FDI	ENGINEERING CHANGE ORDER		ECO NO: 13-021
			Page 1 of 3
TITLE	DWG NO.	CURRENT REV	NEW REV
uEZGUI-1788-43WQR	uEZGUI-1788-43WQR-BA	6.2	7

BACKGROUND:

- Add support for 32MB NOR FLASH with LPC1788
- In supporting the Sharp DG28 LCD on Rev5, which added LCD Sleep/Reset, P0.31 was added to control to drive LCD Sleep/Reset. This signal (P1.31) also goes to the expansion connector. This may cause issues with customers that use P1.31 and do not realize the potential conflict. As a result, zero ohm resistor options are being added to alternatively move the pin from connecting to the expansion connector with alternate P5.1
- The SMT Speaker is no longer available. An SMT Annunciator is being added as a replacement. The SMT Speaker footprint remains for special requirements only.
- Change silkscreen labeling to show the product part number: uEZGUI-1788-43WQR-BA

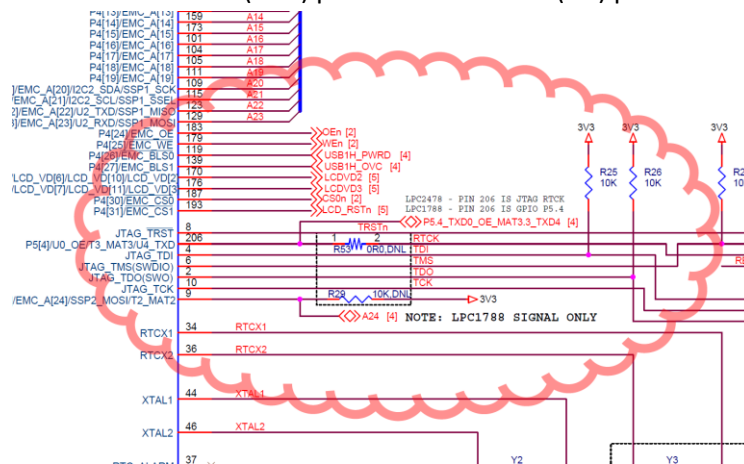
1. Add connection 'A24' from LPC1788 (U11) pin 9 to NOR FLASH (U9) pin 1

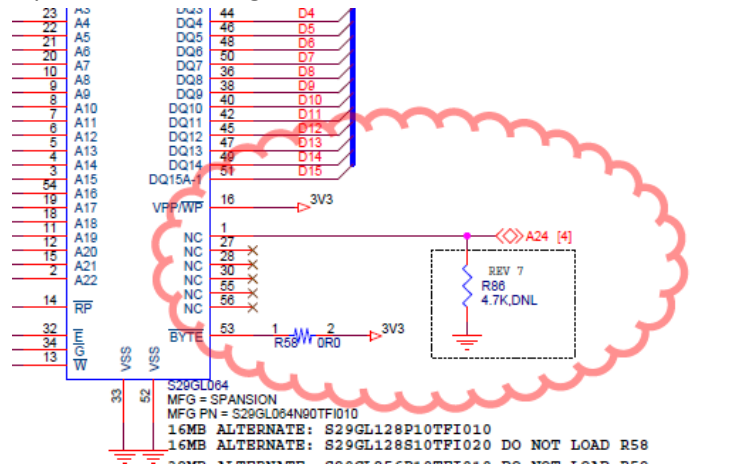
2. Add optional 4.7K pulldown to the signal A24

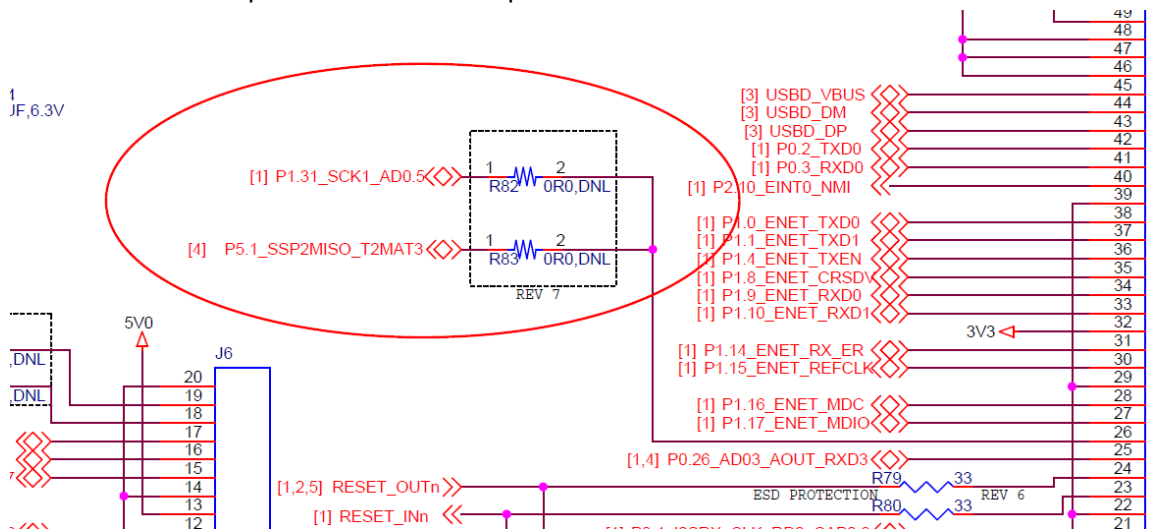
3. Add 2X optional zero ohm option resistors R82 & R83 to alternatively select P1.31 or P5.1 be connected to the expansion connector J2 pin 26. Default will be NO connection.

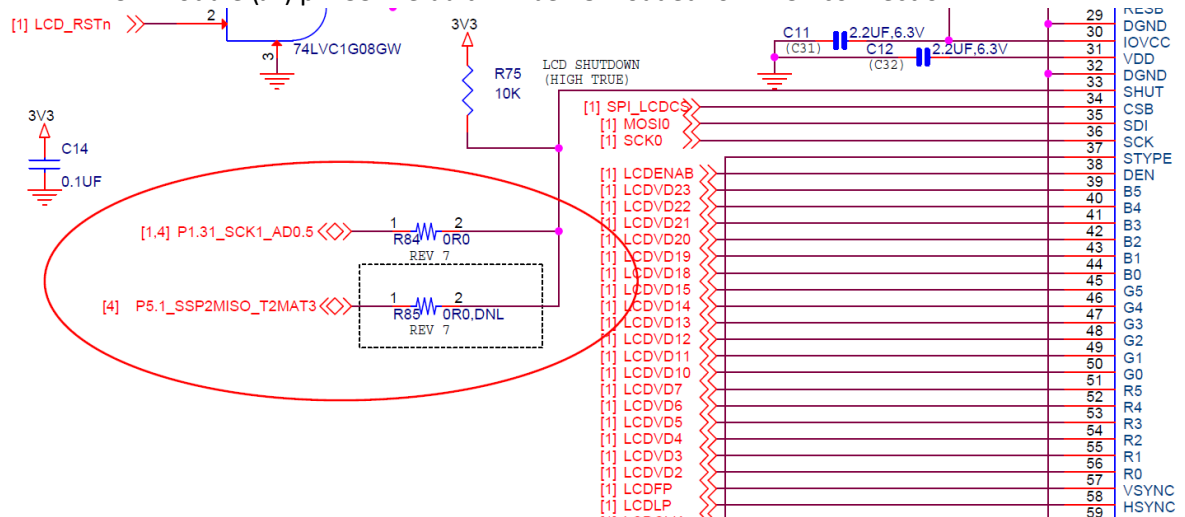
4. Add 2X zero ohm resistors (R84 & R85) to alternatively select P1.31 or P5.1 be connected to the LCD Module (J1) pin 33. Default will be R84 loaded for P1.31 connection.

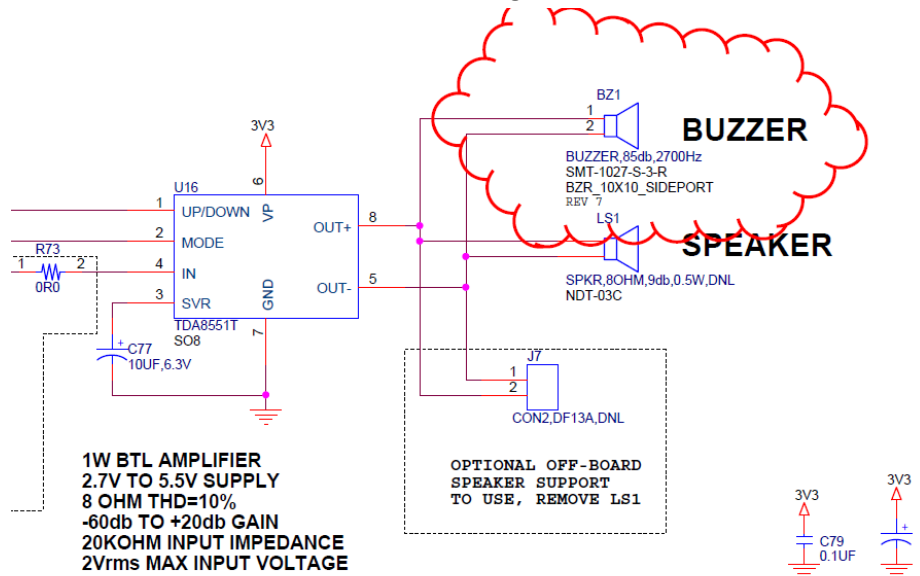
5. Add SMT Buzzer, BZ1, PN SMT-1027-S-3-R and change the LS1 to 'DNL'
